Reference: Results of the Biological Survey for the Illumina Fuel Cell Project (RECON Number 7783-2)

**SUBJECT: Geotechnical Addendum #1
Permanent Soil Nail Retaining Wall and
Conduit Duct Bank Location
Exterior Fuel Cell Installation For
ILM001.0 - Illumina, Inc.
5200 Illumina Way
San Diego, California**

**SUBJECT: Geotechnical Addendum #2
Response to City of San Diego LDR Review Comments**

- Figure 1 Geologic / Geotechnical Map
- Figure 2 Geologic Cross Sections A-A' and B-B'

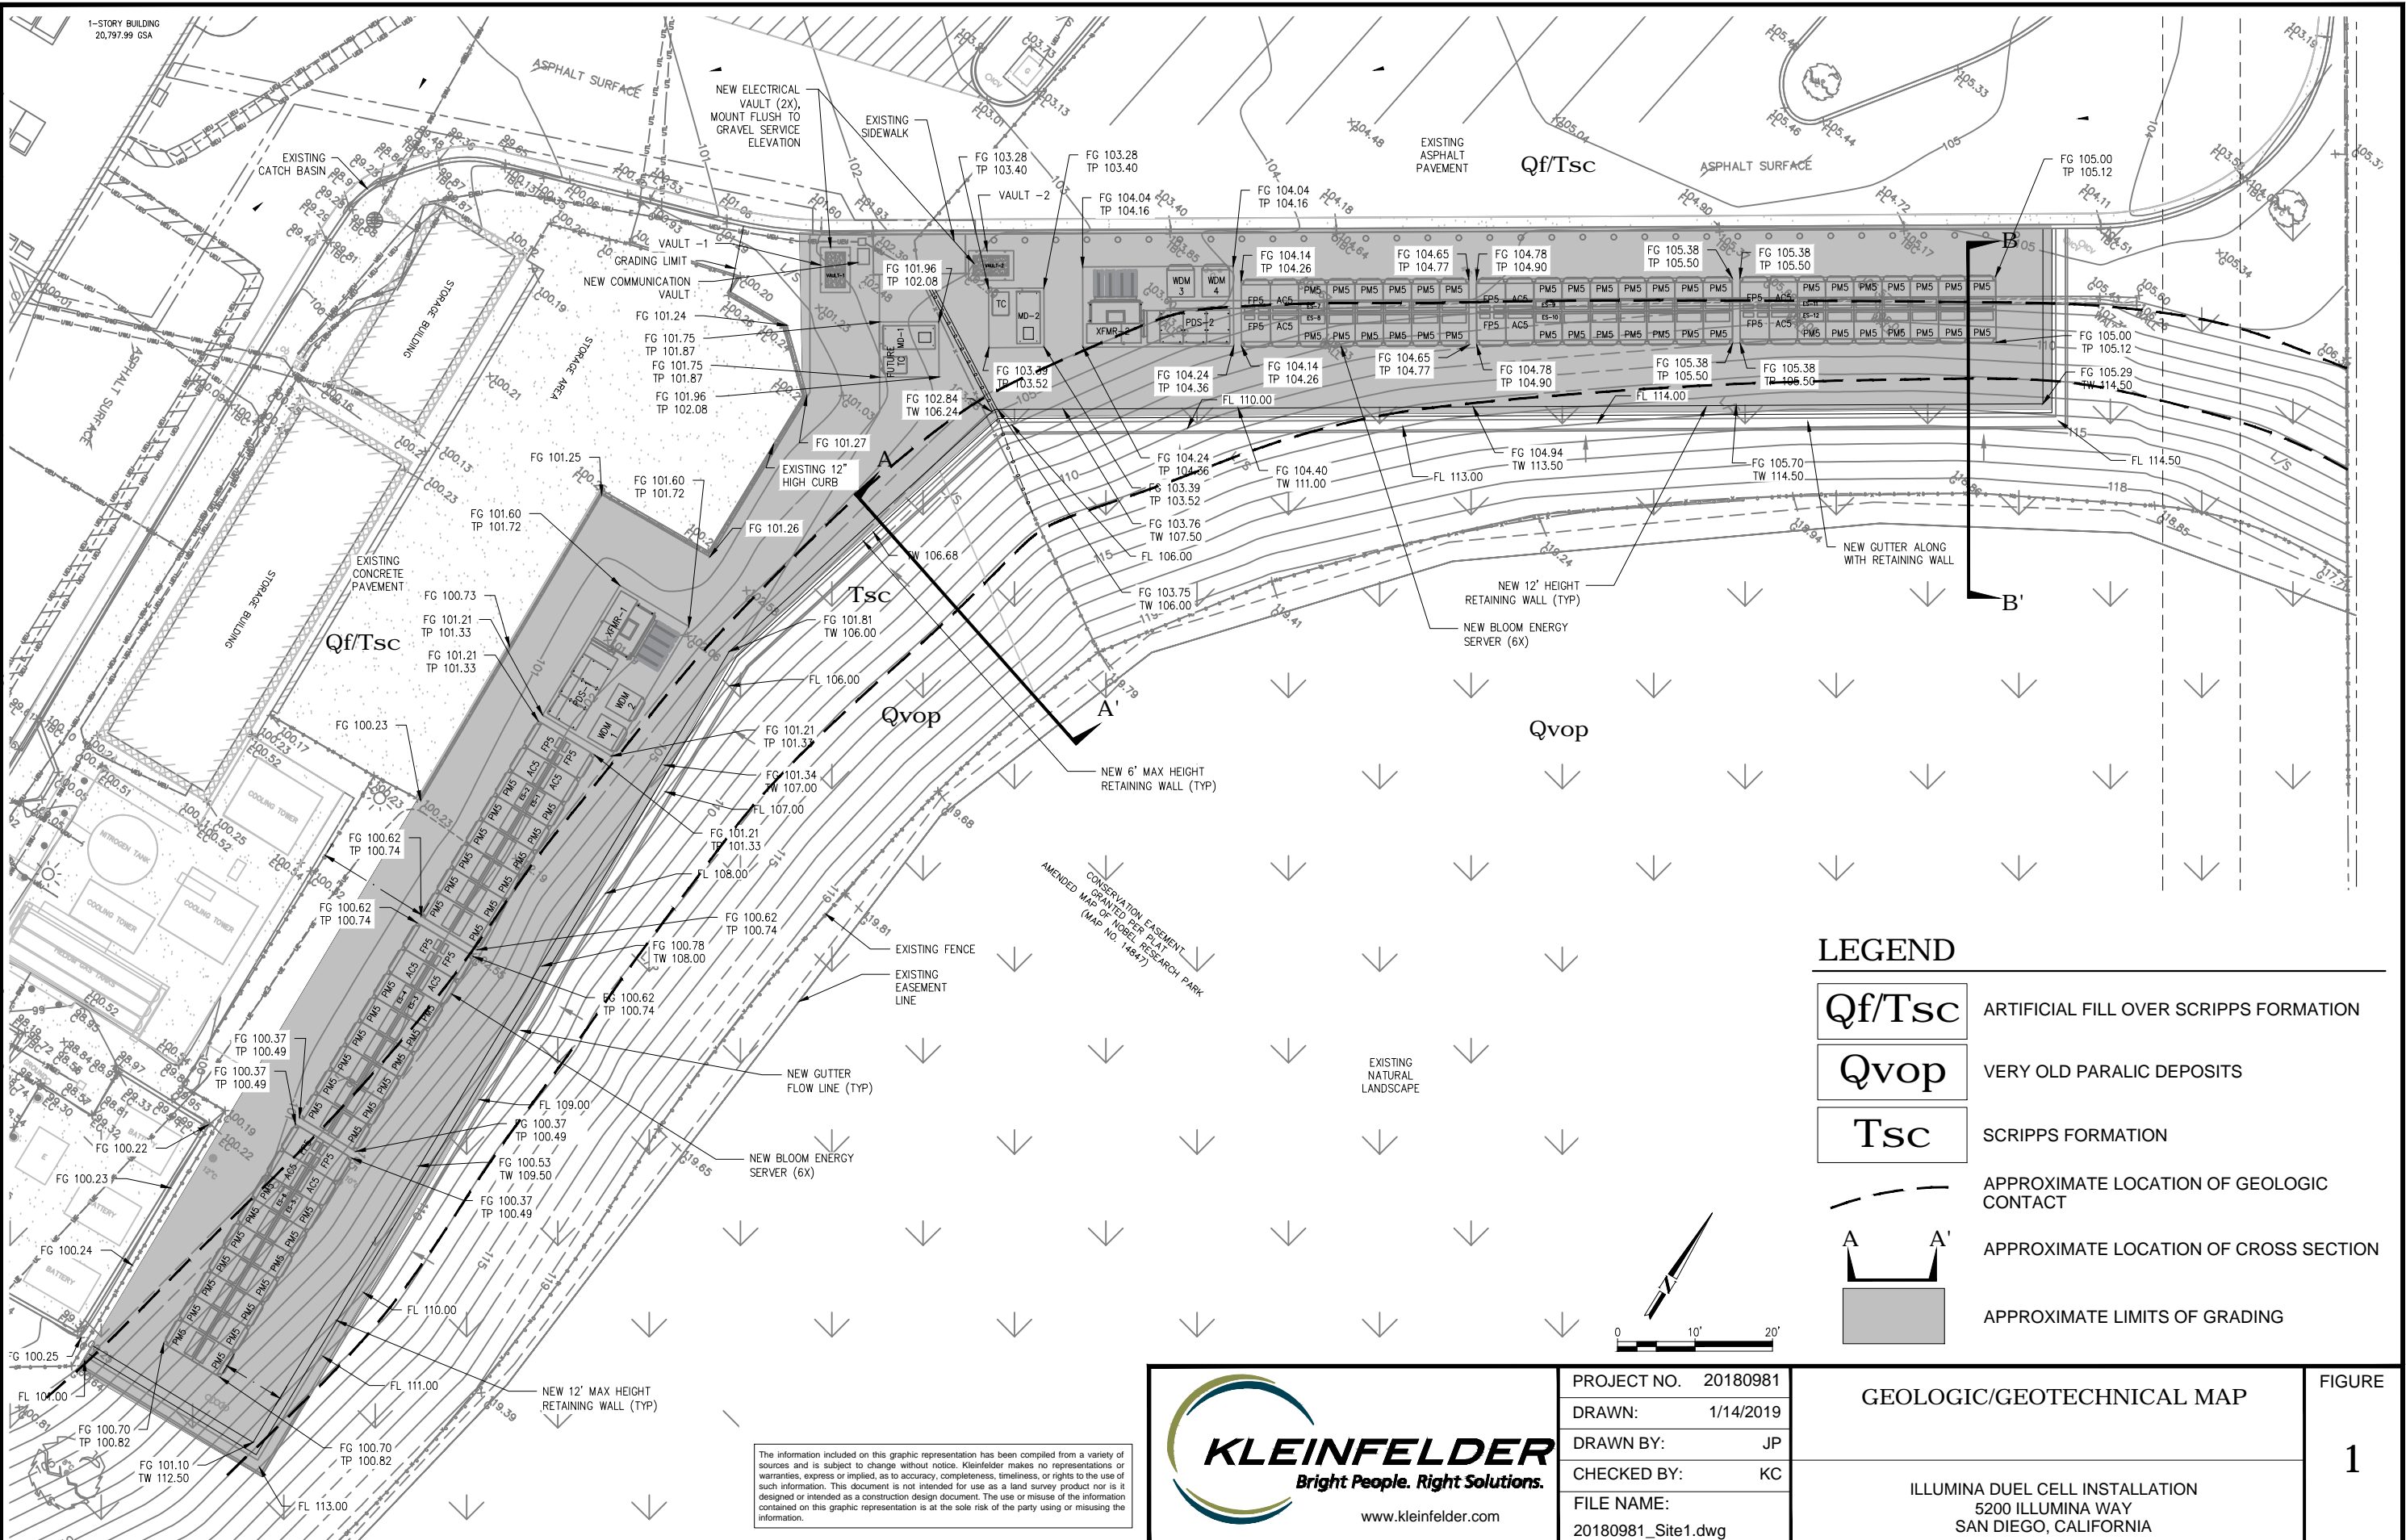
Comment 4. Provide a site-specific geologic/geotechnical map that depicts geologic structure (bedding, joints, faults, etc.), distribution of geologic units, and location of cross sections. The map should be on the topographic base that shows the proposed development.

Comment 5. Show the anticipated limits of remedial grading and limits of temporary slopes on the geologic/ geotechnical map.

Response. The requested geologic/geotechnical map is attached as Figure 1. Note that the geologic structure is not indicated on the map as the both the Scripps Formation and the very old paralic deposits are generally horizontal with potential shallow dip on the order of 2 to 5 degrees. An accurate measurement could not be obtained for purposes of this study. There are also no faults or joints to plot.

Response. The anticipated limits of grading for the shallow removal and recompaction are shown on the attached geologic/ geotechnical map. As discussed in Addendum 1, temporary slopes are no longer part of the project since a near vertical permanent soil nail retaining wall is currently being designed. The wall will be constructed in sequenced top-down construction with approximate 5-foot vertical lifts.

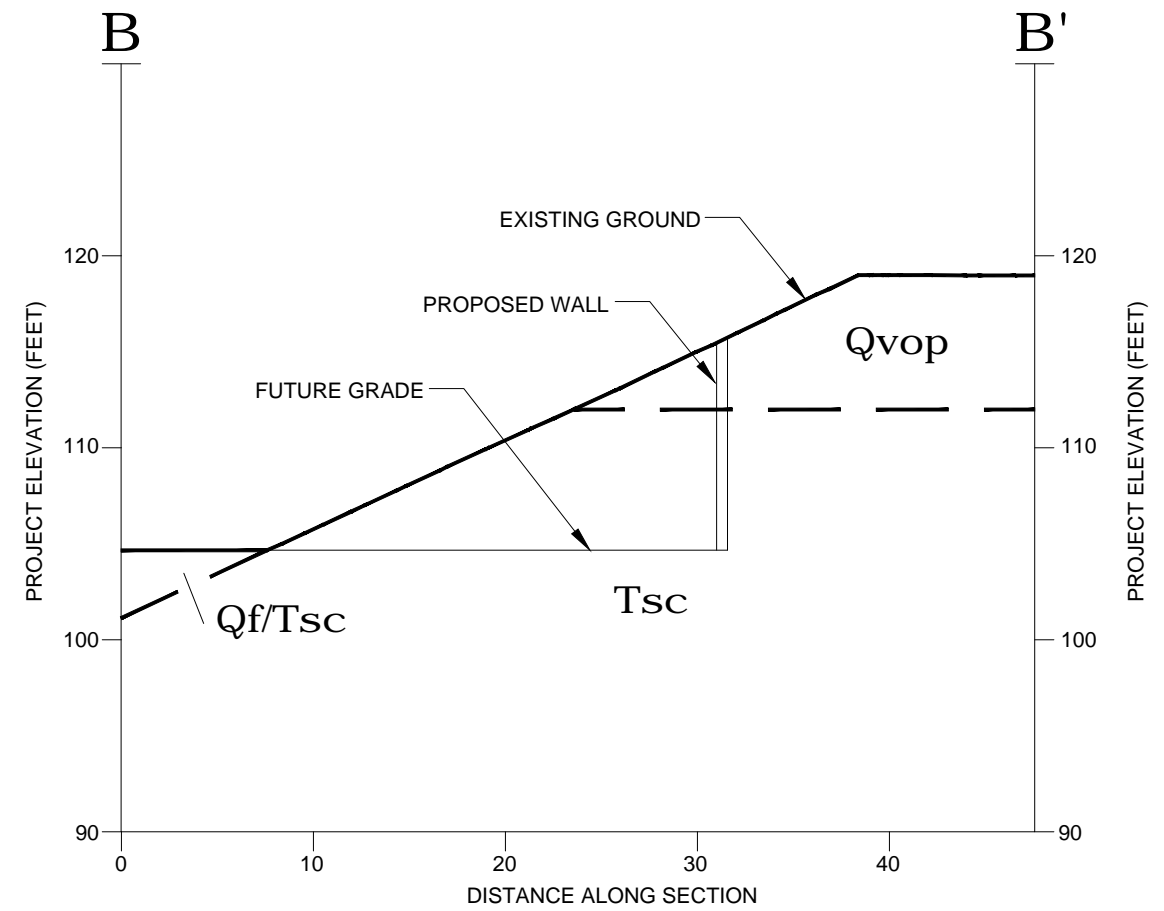
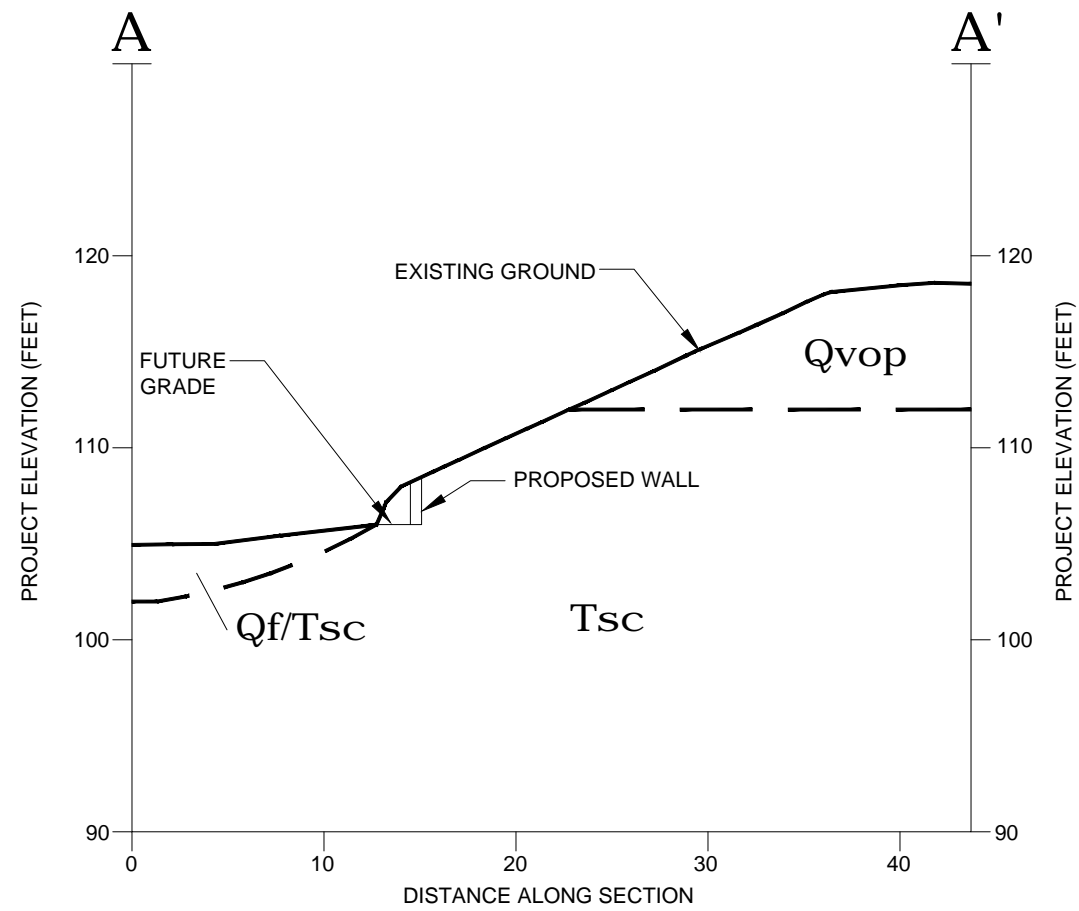
Comment 6. Provide geologic/ geotechnical cross-sections representative of the site conditions and proposed development.

Response. Two geologic/ geotechnical cross-sections are attached as Figure 2 and represent areas with higher and lower wall heights.
